HUB Cycling Maple Ridge/Pitt Meadows

Suggested spot improvements:

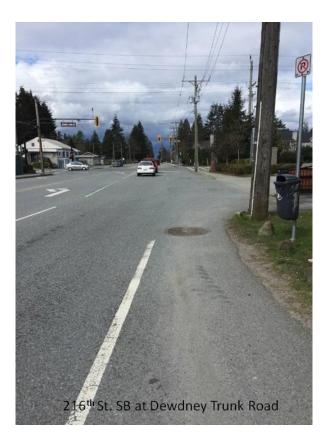
• 350 216 St. at Dewdney Trunk Road: Painted bike lane ends abruptly into vehicle lane with nothing to indicate where bicycles should go. (photo below) It would be great if we could get some sharrows there, with "single file/share the road" signs or "right lane must turn right except bicycles". (KR)
